Project	IEEE 802.16 Broadband Wireless Access Working Group < http://ieee802.org/16 >	
Title	DIUC/UIUC provision for supporting multiple advanced FEC types	
Date Submitted	2005-06-08	
Source(s)	Bin-Chul Ihm, Yongseok Jin, Kiseon Ryu, Changjae Lee and JinYoung Chun LG Electronics, Inc.	Voice: 82-31-450-7187 Fax: 82-31-450-7912 bcihm@lge.com
Re:	This is a response to a Call for Comments on IEEE P802.16e-D8	
Abstract	Provision of more DIUC rooms for supporting the multiple advanced FEC types.	
Purpose	This document is submitted for review by 802.16e Working Group members	
Notice	This document has been prepared to assist IEEE 802.16. It is offered as a basis for discussion and is not binding on the contributing individual(s) or organization(s). The material in this document is subject to change in form and content after further study. The contributor(s) reserve(s) the right to add, amend or withdraw material contained herein.

DIUC/UIUC provision for supporting multiple advanced FEC types

Bin-Chul Ihm, Yongseok Jin, Kiseon Ryu, Changjae Lee and Jinyoung Chun
LG Electronics

Figure 2. Proposed scheme for providing enough MCS levels i.e., DIUC/UIUC's for each FEC type

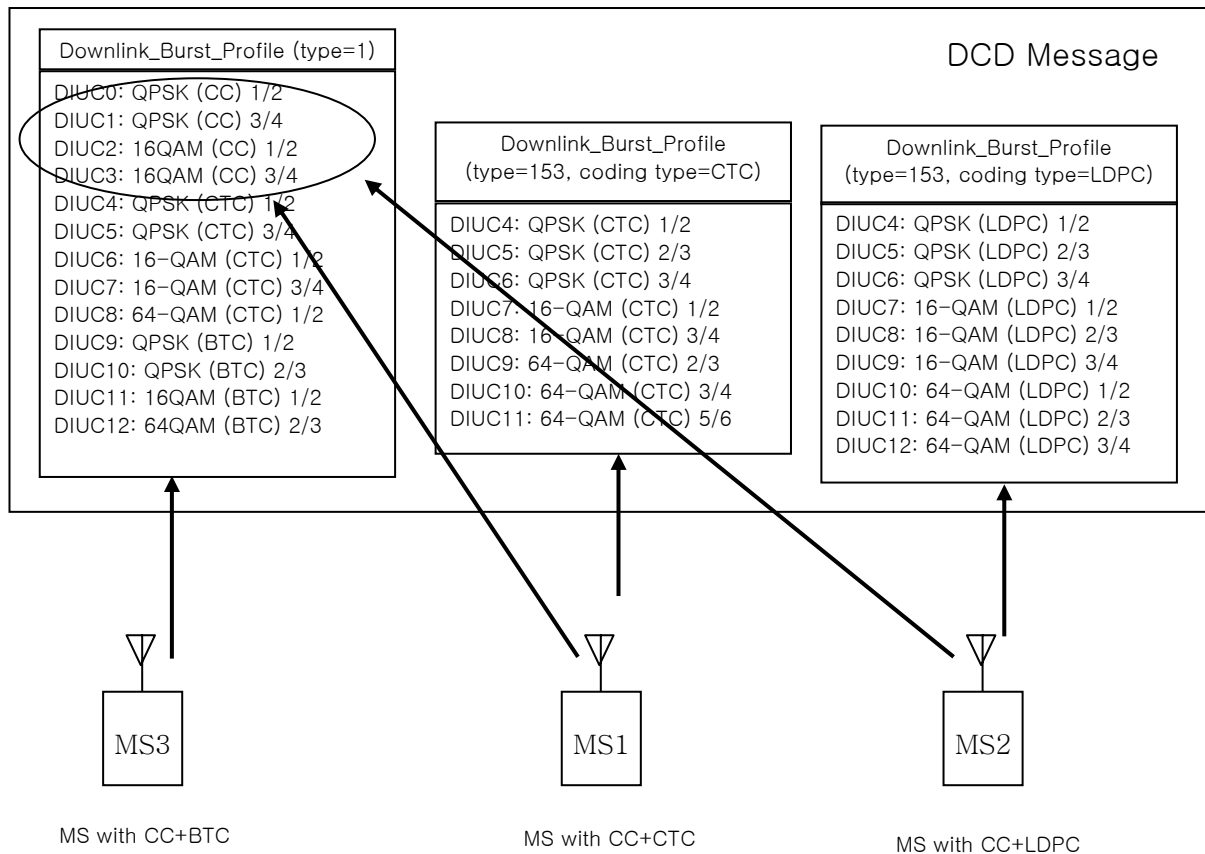
To provide more rooms for DIUC(UIUC) per each FEC type, we propose the extended DIUC(UIUC) which are dedicated to each FEC type as shown in Figure 2. 802.16-2004 version MS refers its DIUC(UIUC) set from downlink(uplink)_burst_profile and the later version MS can refer its DIUC(UIUC) set from each extended downlink(uplink)_burst_profile and downlink(uplink)_burst_profile for CC. In Figure 2, DIUC10 can be interpreted as one of three meanings of QPSK (BTC) 2/3, 64-QAM (CTC) 3/4 or 64-QAM (LDPC) 1/2 according to FEC type of MS. When there is no extended downlink(uplink)_burst_profile, the later version MS shall refer its DIUC(UIUC) set from the current downlink(uplink)_burst_profile.

Figure 3. SBC_RSP message to restrict MS to use just one optional FEC type

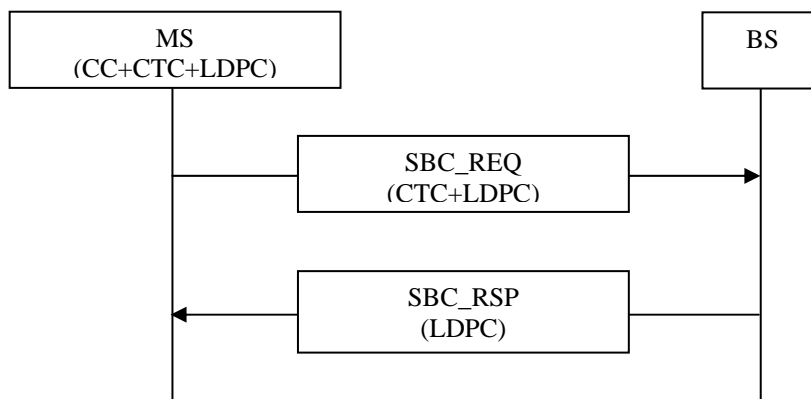
For example, when a MS was equipped two optional FEC such as CTC+LDPC, the proposed scheme results in confusion of DIUC(UIUC) definition. In this case, BS should restrict just one of two optional FEC types on the MS available after reception of SBC_REQ indicating that MS has CTC+LDPC capability. This restriction can be delivered to the MS through SBC_RSP message.
